## GUERNSEY COOLER FREEZER ADDITION JSP23-39

**PLAN REVIEW CENTER REPORT**  
**Planning Review**  
**GUERNSEY COOLER FREEZER ADDITION**  
 JSP 23-39  
 March 6, 2024

Revised Combined Preliminary and Final Site Plan

Section	36	
Site Location	21300 Novi Road; 22-35-301-001	
Site School	Novi Community School District	
Site Zoning	B-3 General Business District	
Adjoining Zoning	North	B-3 General Business District
	East	R-4 One-Family Residential
	West	City of Northville; Residential
	South	R-4 One-Family Residential
Current Site Use	Guernsey Dairy Restaurant and Ice Cream	
Adjoining Uses	North	Border Cantina
	East	Residential, separated by railroad
	West	Residential, separated by Novi Road
	South	Residential, separated by railroad
Site Size	2.48 acres	
Plan Date	Submitted October 24, 2023

PHASE: SPA  
 JOB NO.: 210201  
 C100

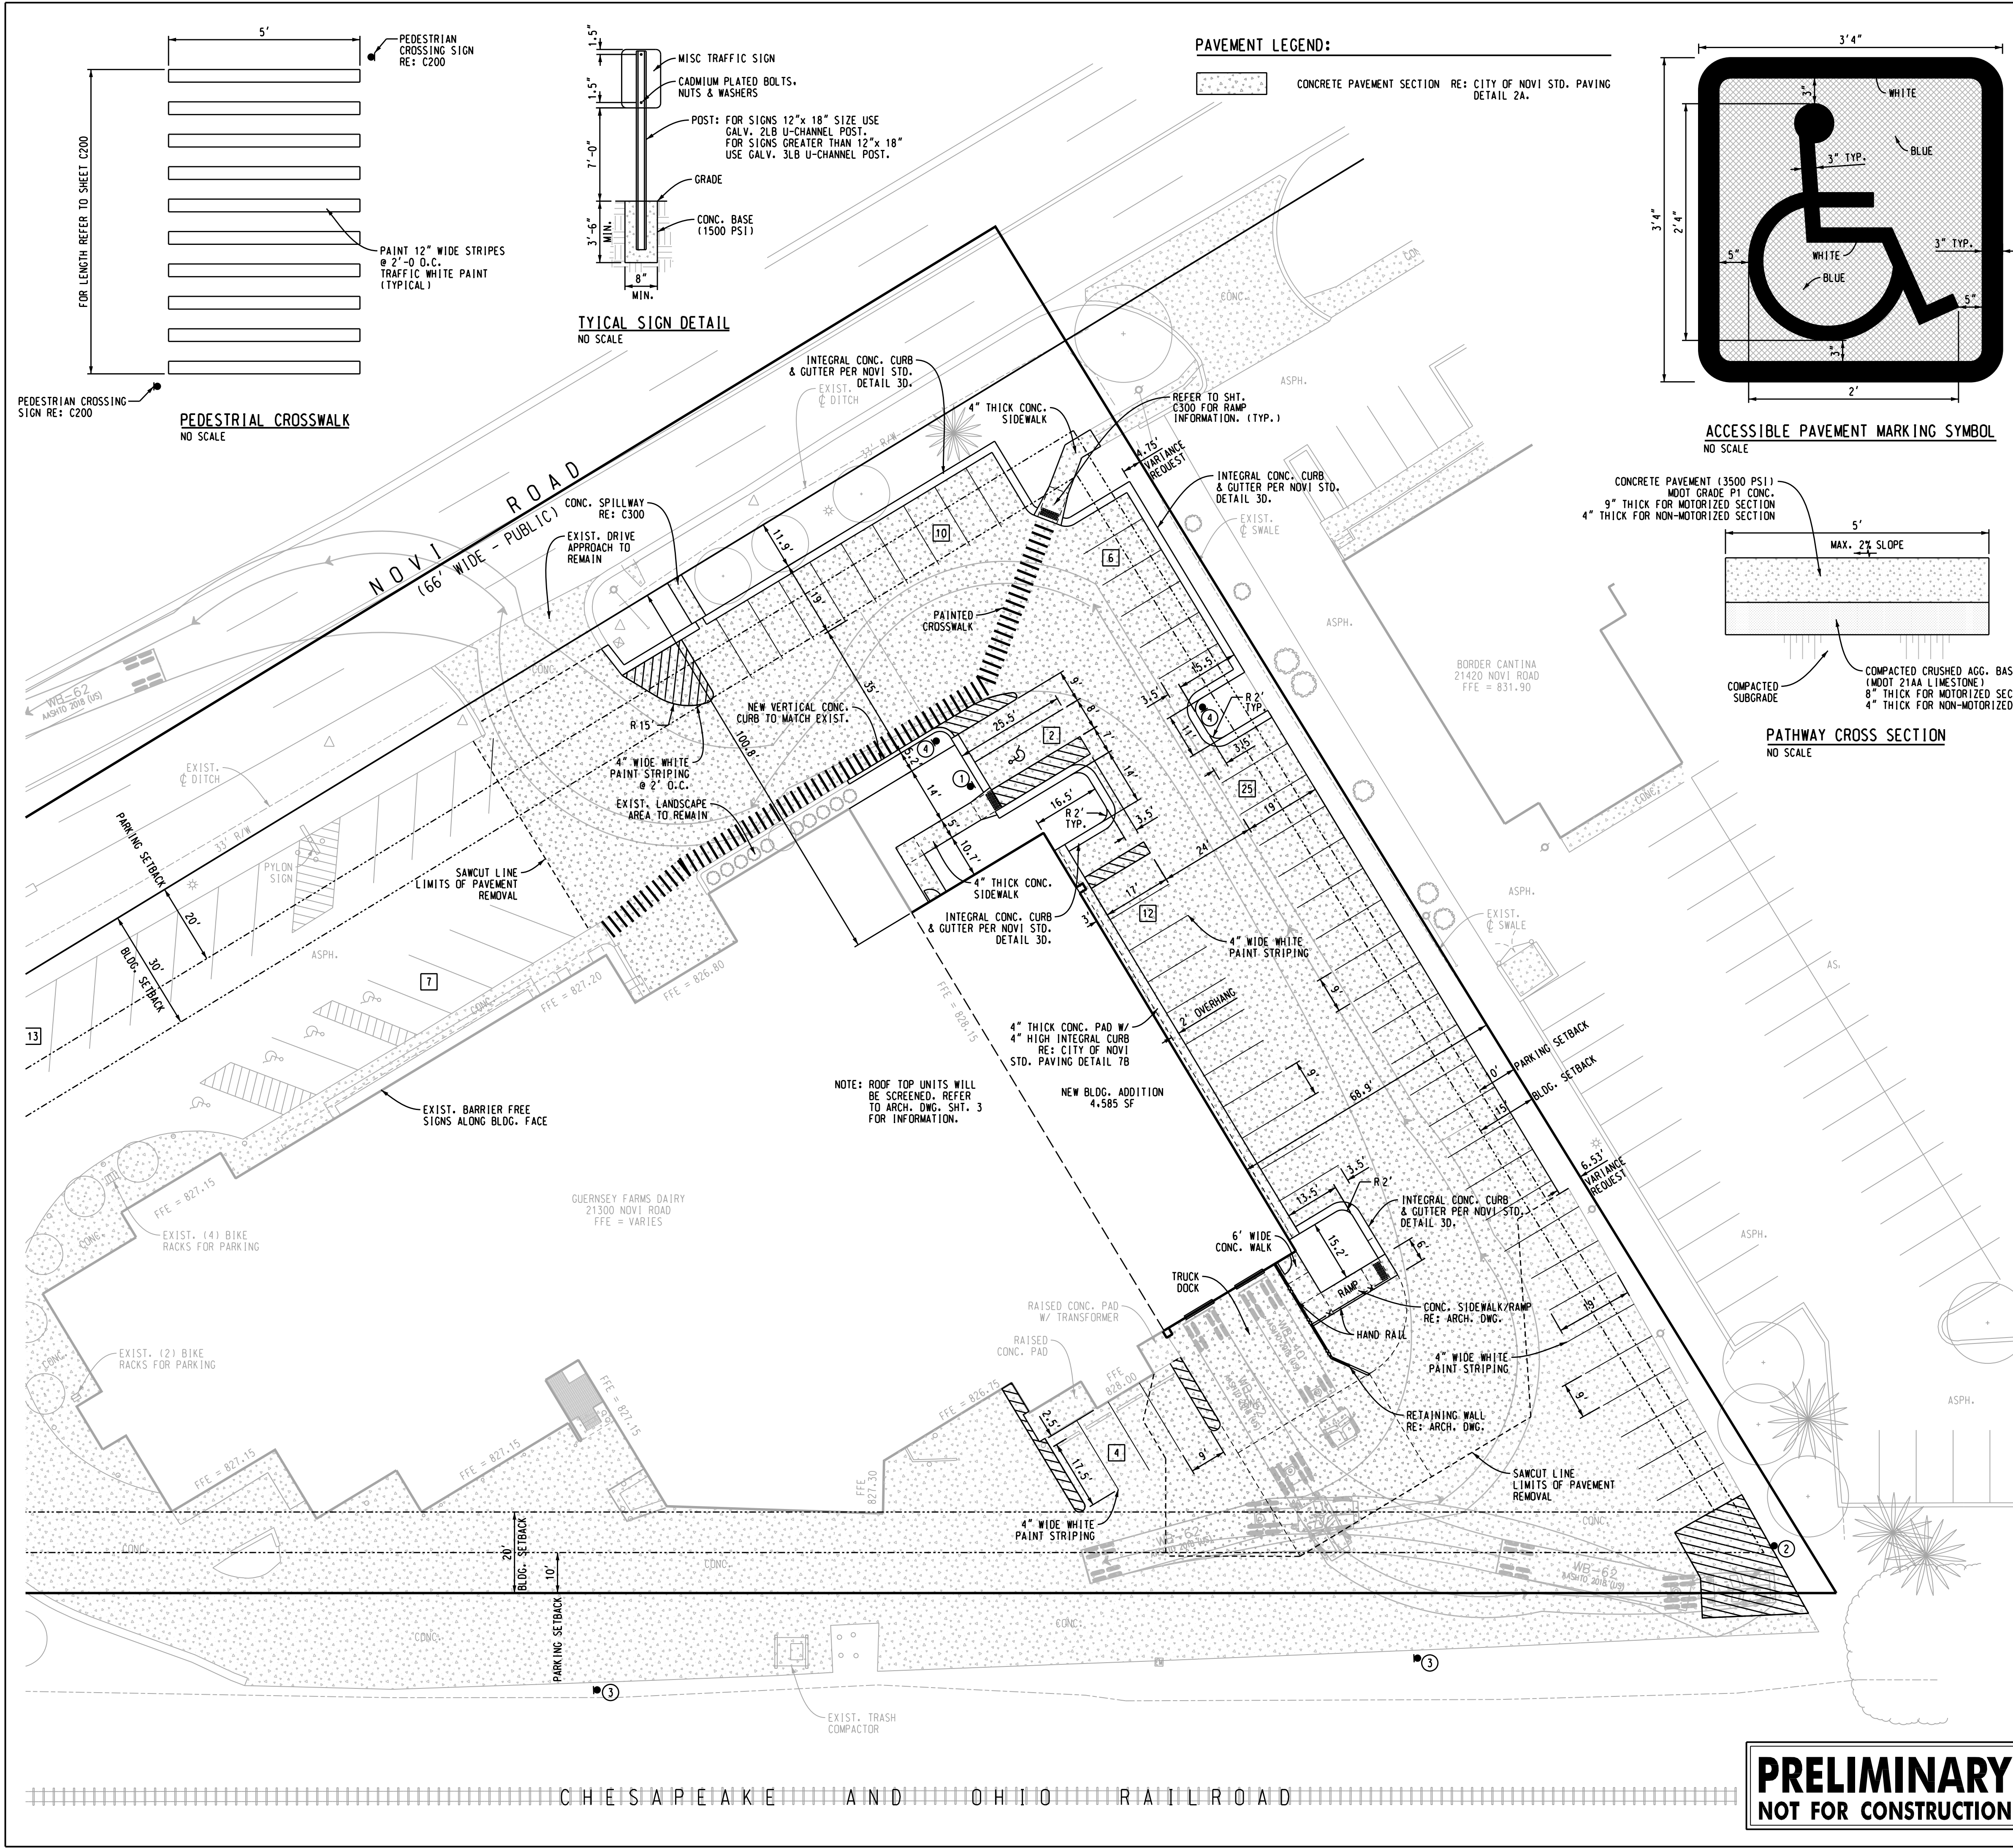
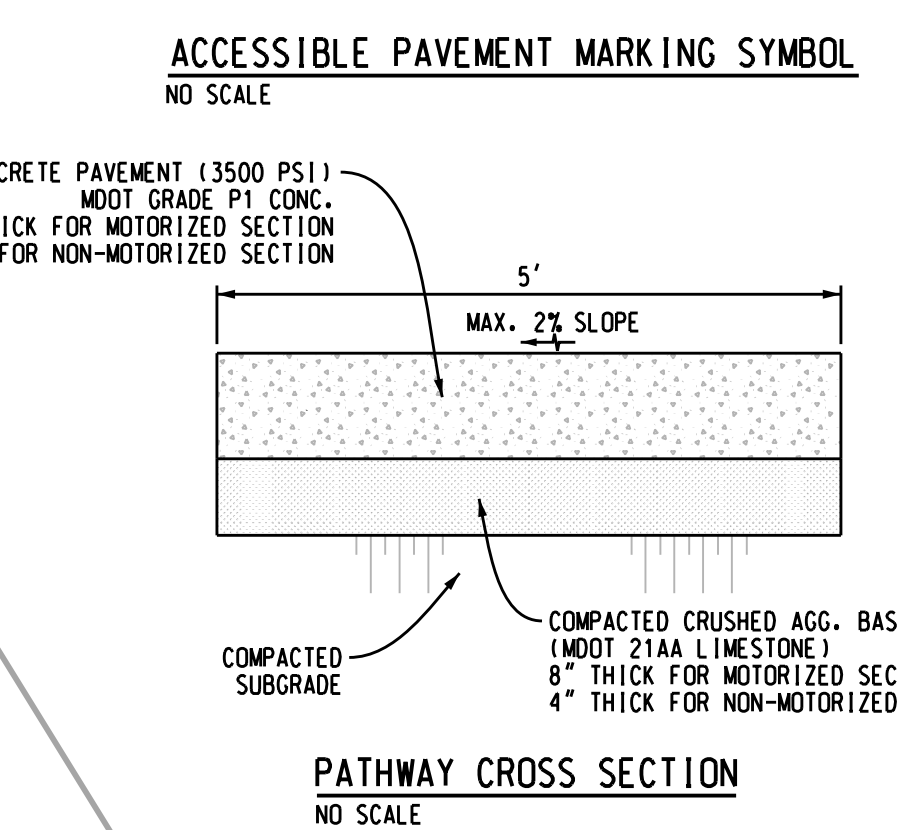
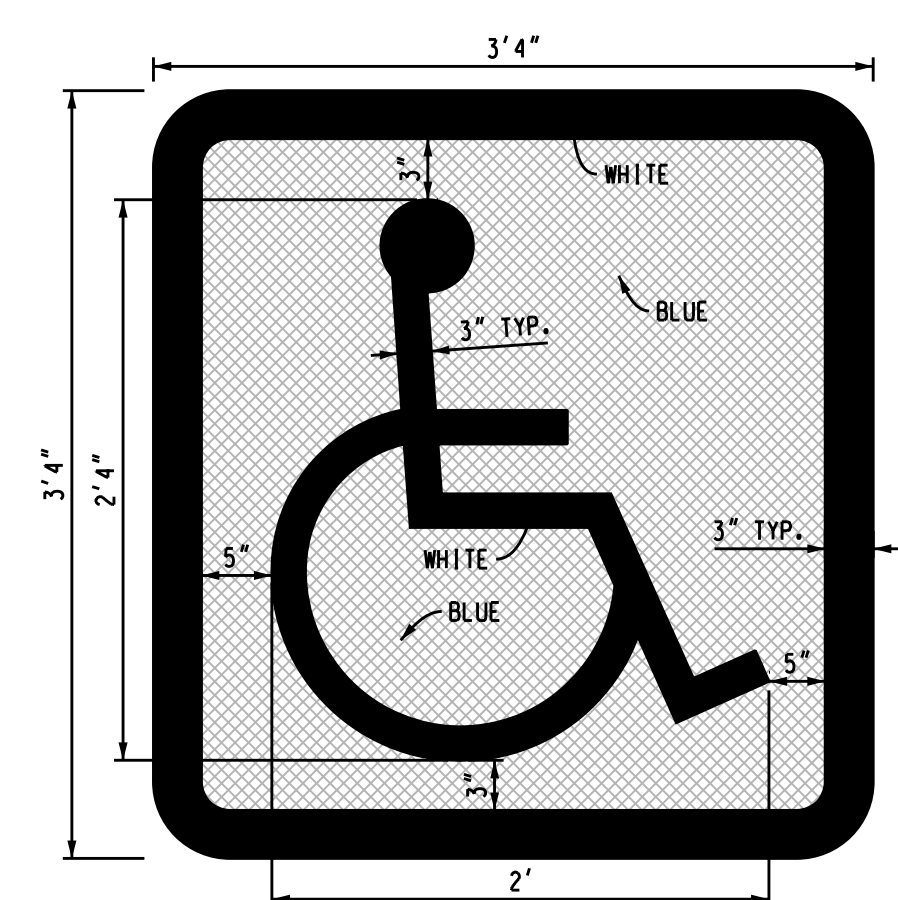
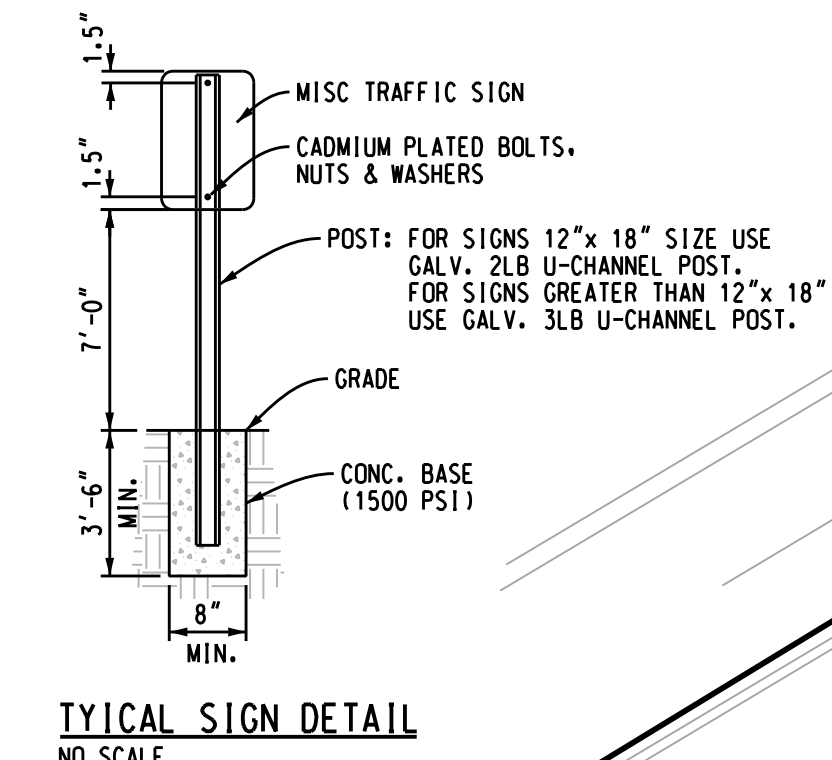
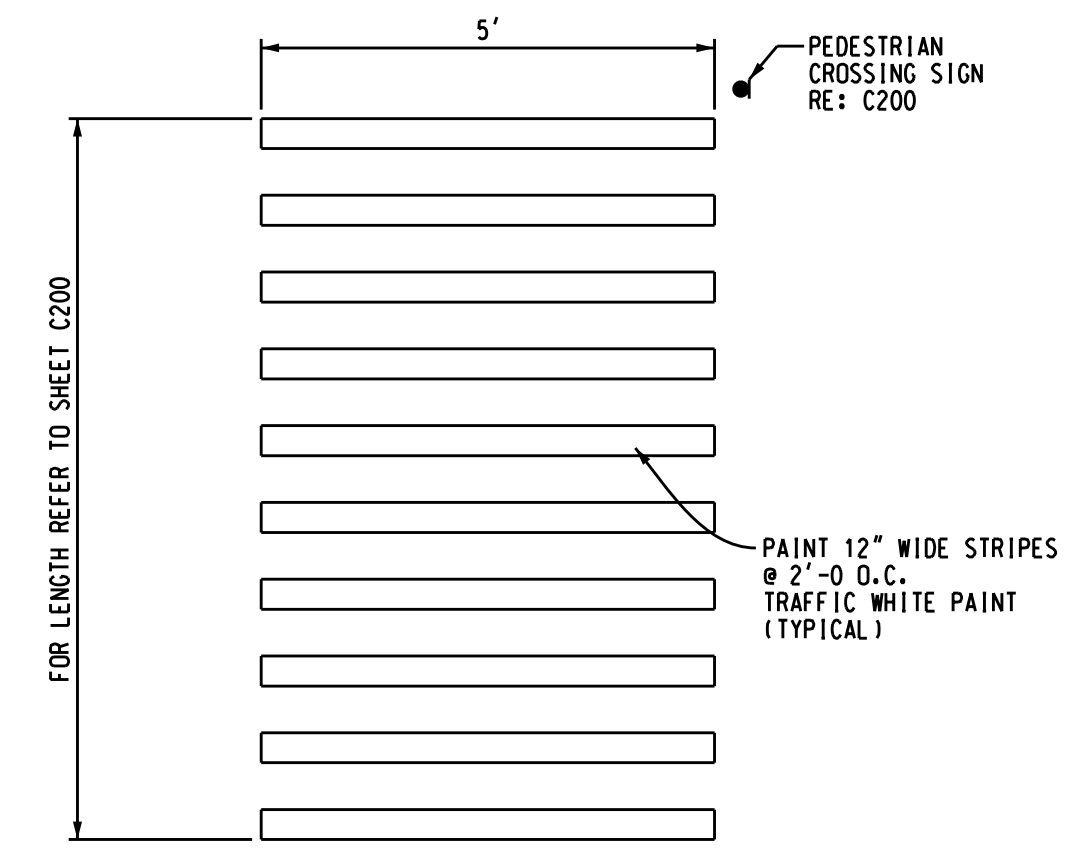
1. Parking Setbacks (Sec. 3.1.12.D): Side yard parking to the north is an expansion of a nonconformity, and front yard parking to the west may also be a slight expansion of a nonconformity. There is conflicting information on sheet 1 and sheet C200 – sheet 1 shows the front yard parking setback to be 13 ft. 10 in. while Sheet C200 shows it to be 11.9 ft. **This should be clarified. Because the total parking setback area remains deficient compared to what is required, the Planning Commission cannot modify the parking setback as provided in Section 3.6.2.Q. The parking setbacks that do not comply will therefore require a variance from the ZBA. Required ZBA variance acknowledged by the applicant.**

2. Building Setbacks
  - a. Setback labels added to plans. See sheets 1, C100, & C102.
3. Parking Setbacks
  - a. Setback labels added to plans. See sheets 1, C100, & C102.

1. Additional information has been provided regarding utilities and easements. See sheets C100 & C101.
2. Site plans were altered in accordance with Chapter 11 of the City of Novi Code of Ordinances. Review sheets C100, C101, C102, C200, C300, & C400.
3. A sheet index is provided on sheet 1.
4. Right-of-way is indicated on sheets C100 & C101.
5. Understood.
6. Existing and proposed utilities are located on sheets C101 & C300.
7. Understood. We are still seeking information about a previous payment to the sidewalk fund. (JOE KINVILLE SAID THAT HE COULD NOT FIND ANYTHING)
8. The dimensions of parking stalls are on sheet C200.
9. Upon review we do not require a Joint Permit Application.
10. The limits of the 100-year floodplain are on sheet C101.
11. For elevations see sheets C101 & C300.
12. Agreed.
13. Understood.
